Title: Baseline 1065/1066 Update**Applicability:** MY20 Revero GT and GTS,
and MY21-MY23 GS-6 vehicles**PRIORITY:** Vehicles on list (page 2)**PURPOSE:**

Applicability: MY20 Revero GT and GTS, and MY21-MY23 GS-6 vehicles

Type: Baseline Release

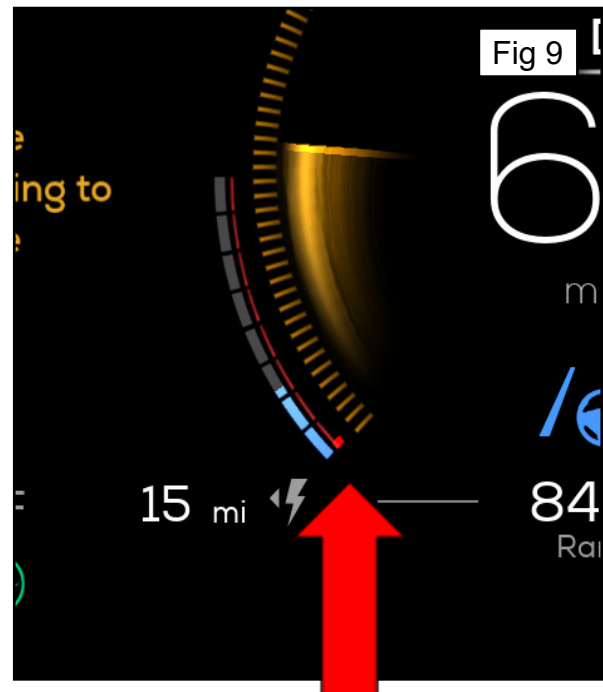
Release notes on new alert during a reduced battery buffer event.

During high demand of energy from the vehicle, should the battery buffer be “degraded” it may be not possible to continue in Stealth or pure EV mode, until the conditions are met.

The vehicle may not allow Stealth mode to be engaged and will force Sustain mode (or Sport if chosen by the driver as of the new “Baseline 1065” release).

Also note the turtle telltale is illuminated! (Fig 8)

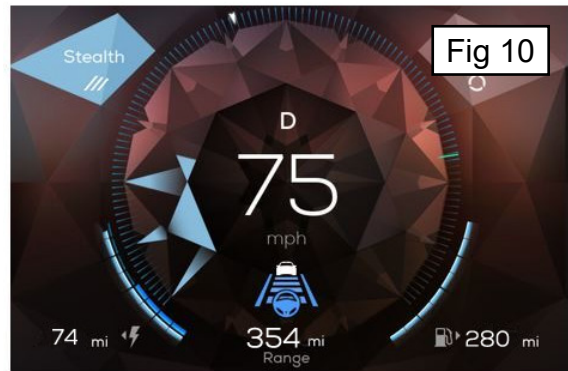
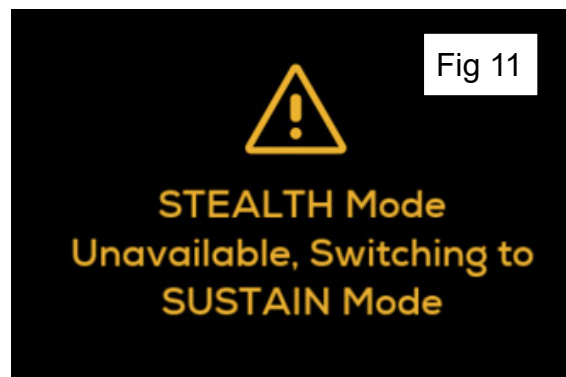
On the diamond back ground DIS, the buffer is in the same location (Fig 10). The Battery Buffer can be seen next to the HV Battery Charge level, here in each image you can see the battery buffer go down to the level where the turtle icon will illuminate and the vehicle will force Sustain mode (engine on).

This message (fig 11) will be seen briefly, the turtle should remain until the condition is improved.
